Addendum No. 2
March 15, 2021

Project: Jane Addams Elelmentary School – C.I.P. Addition And Renovations PD #3312
Project location: 2511 W. Brookings Street, Sioux Falls, SD 57104
Project number: 1105.2914.20

Architect: Architecture Incorporated

FLOOR FINISH PLAN - AREA A
SCALE: 1/8" = 1'-0"

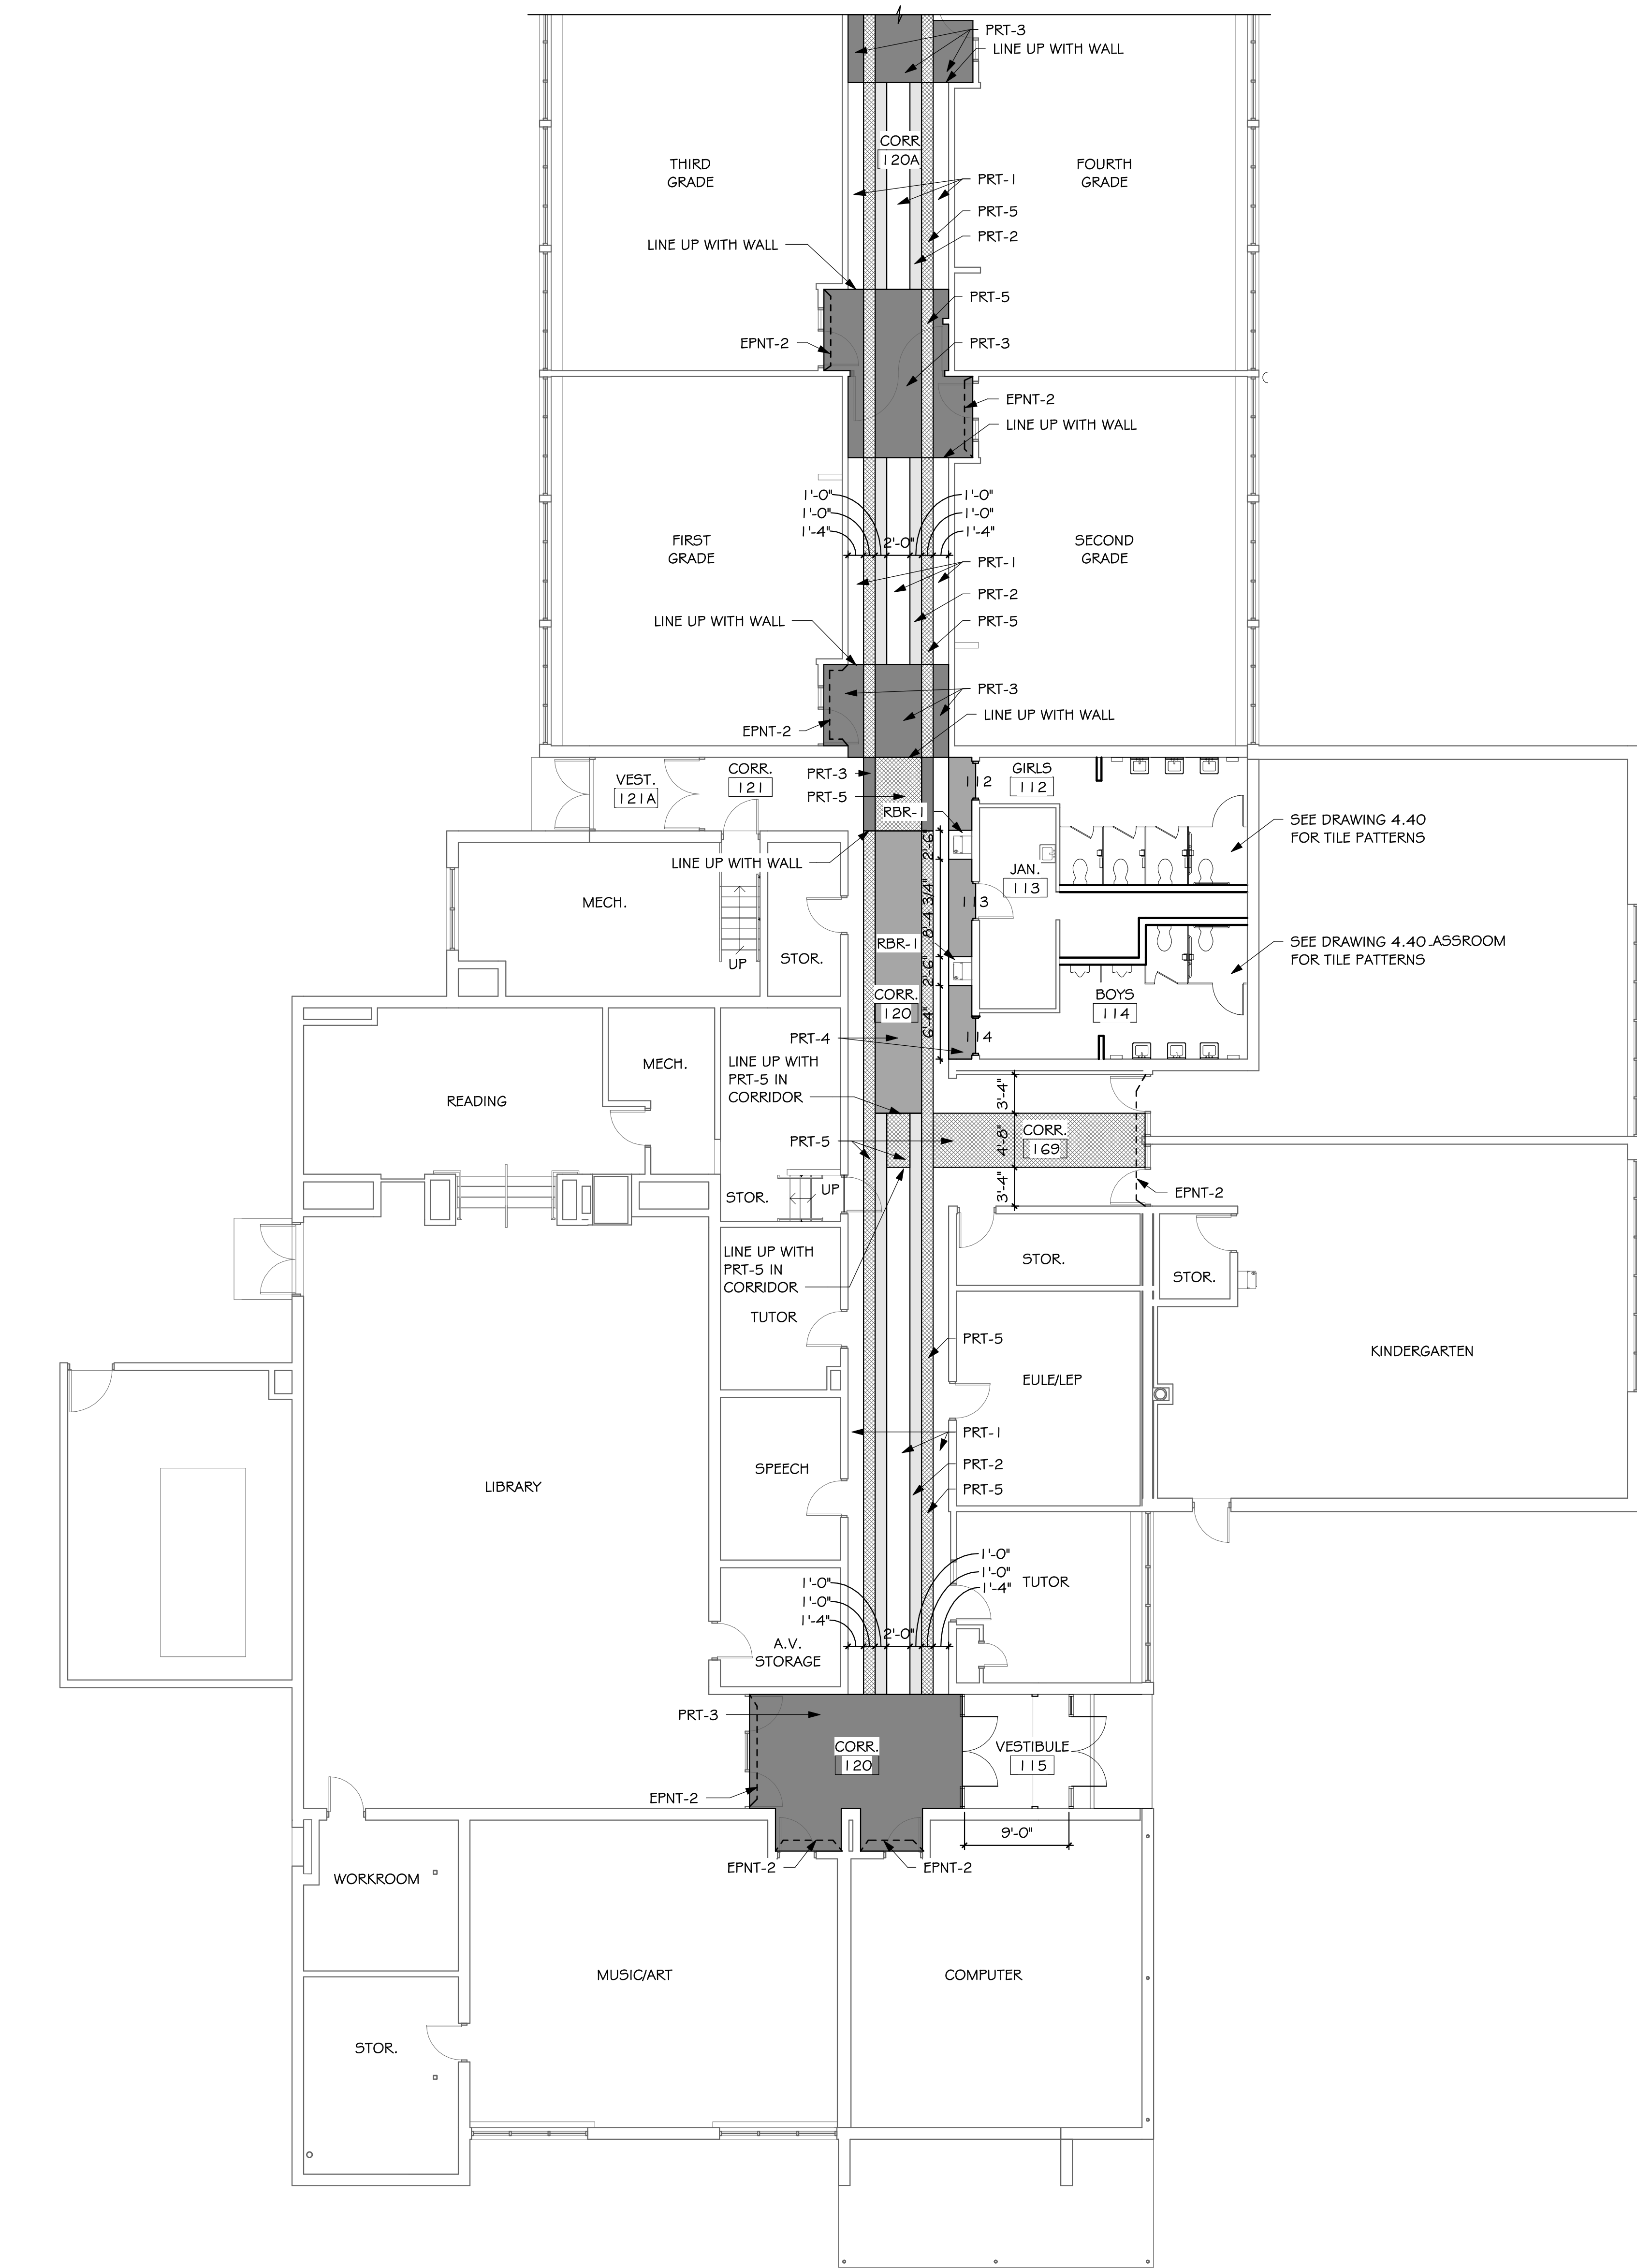
- a) Disregard the PRT floor pattern on this drawing in the plan set. Find the changes to the pattern on the attached new drawing **4.20 FLOOR FINISH PLAN – AREA A**. The finish schedule for the corridors was also updated on this drawing.
 - i) 4.20 FLOOR FINISH PLAN – AREA A attached.
- b) Room 107-BAND/ORD – remove (2) walls labeled as A3, gypsum wall board deflector will not be provided or installed.
- c) Room 108 - MUSIC – remove (2) walls labeled as A3, gypsum wall board deflector will not be provided or installed.

1 FLOOR FINISH PLAN - AREA B
4.2.1 SCALE: 1/8" = 1'-0"

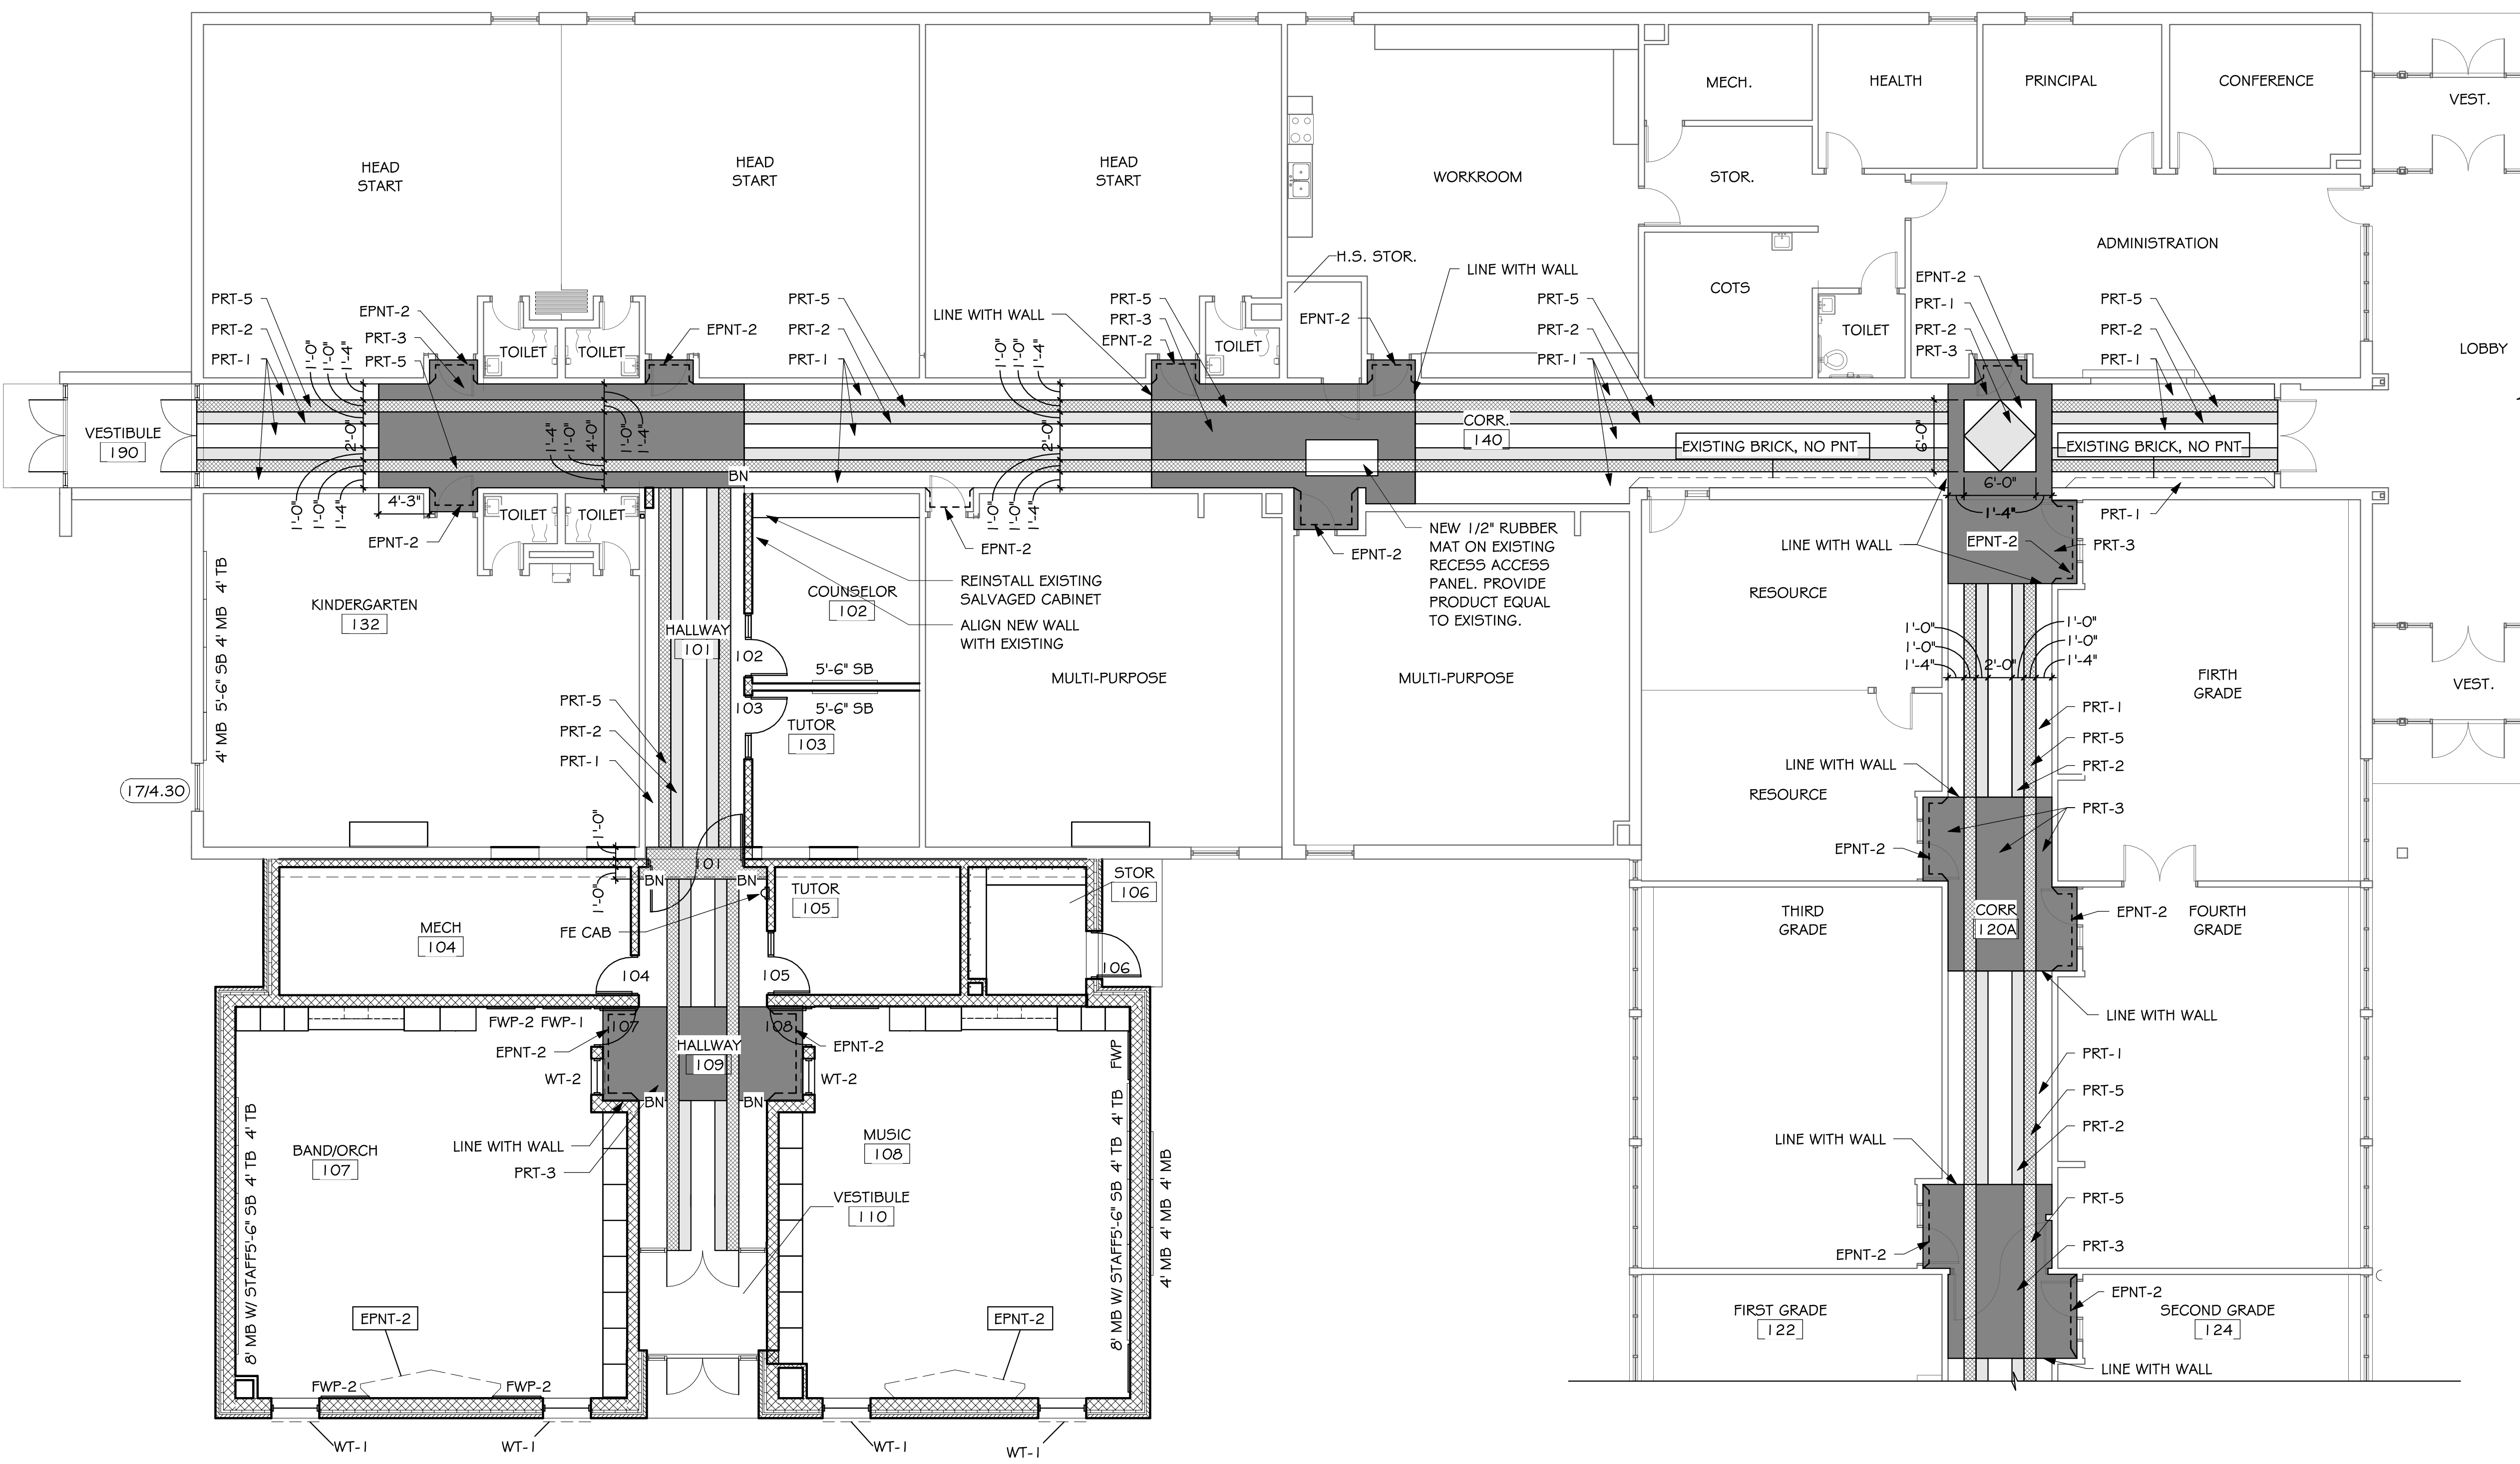
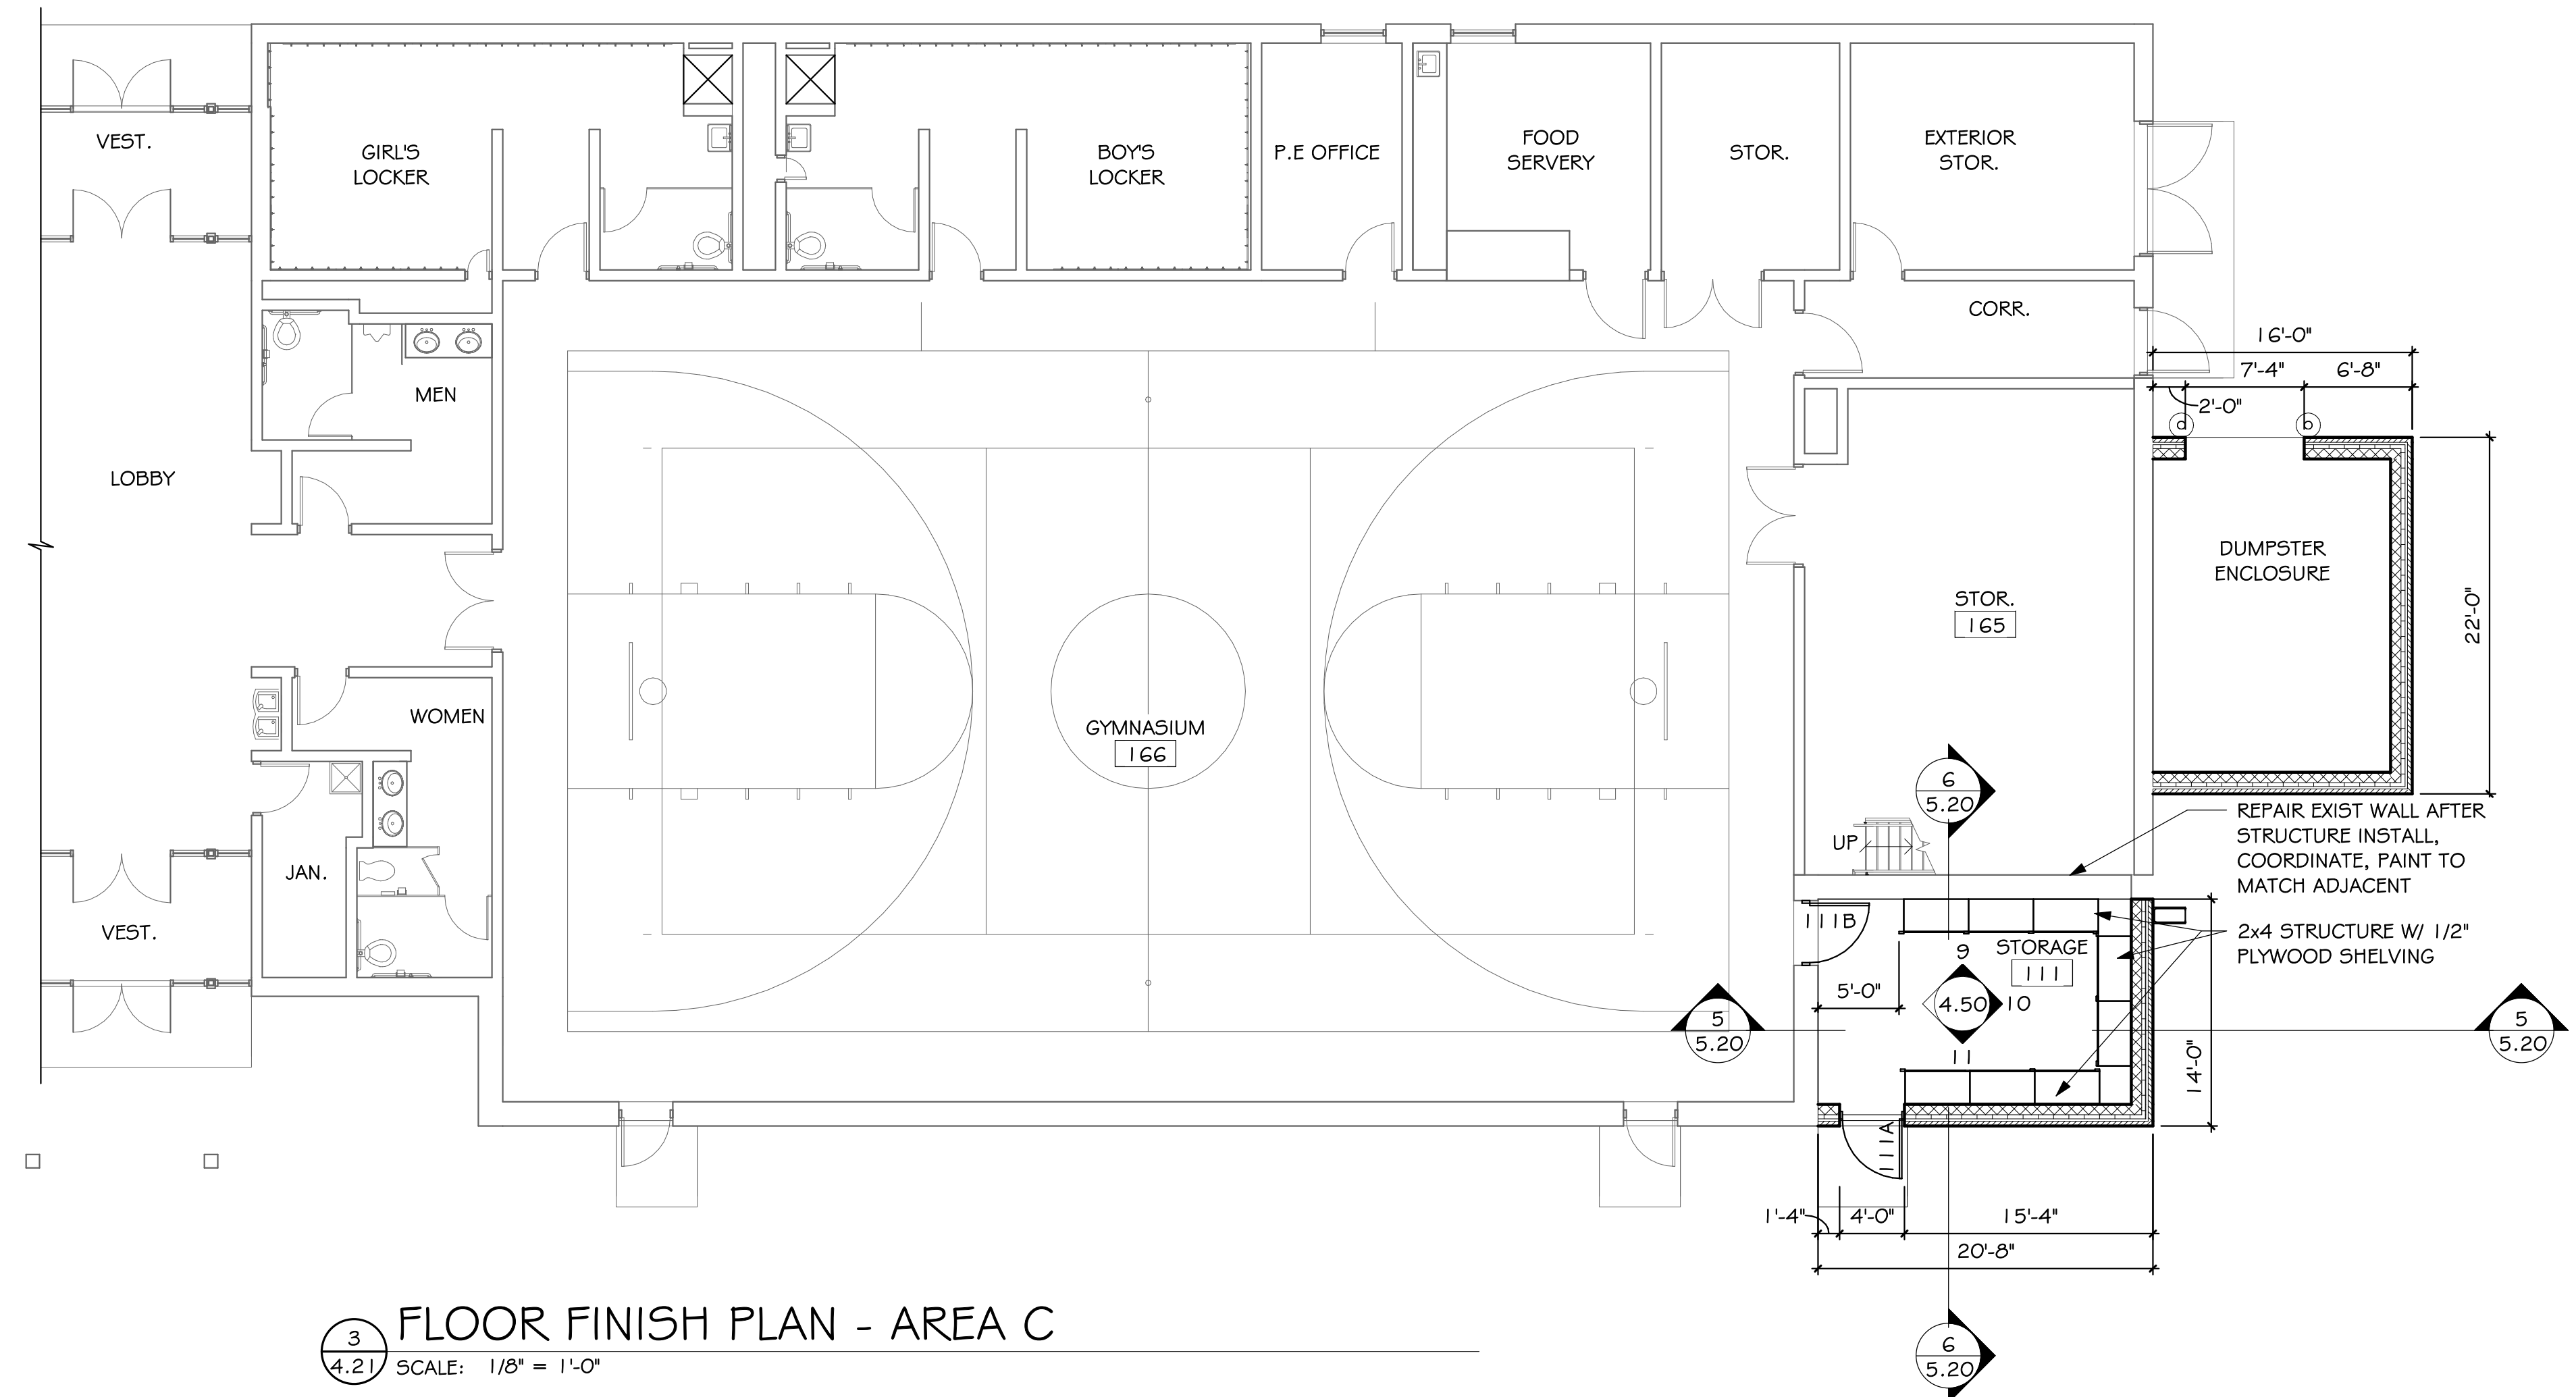
- a) Disregard the PRT floor pattern on this drawing in the plan set. Find the changes to the pattern on the attached new drawing **4.21 FLOOR FINISH PLAN – AREA B & C**. The finish schedule for the corridors was also updated on this drawing.

- i) 4.21 FLOOR FINISH PLAN – AREA B & C attached.
 - (1) Walls at RM 106 – STOR, and RM 111 – STORAGE, EPNT-1 See Finish Schedule sheet 4.21 attached.
 - (2) SEE SHEET 4.21 FLOOR FINISH PLAN AREA B & C for required bullnose masonry locations.
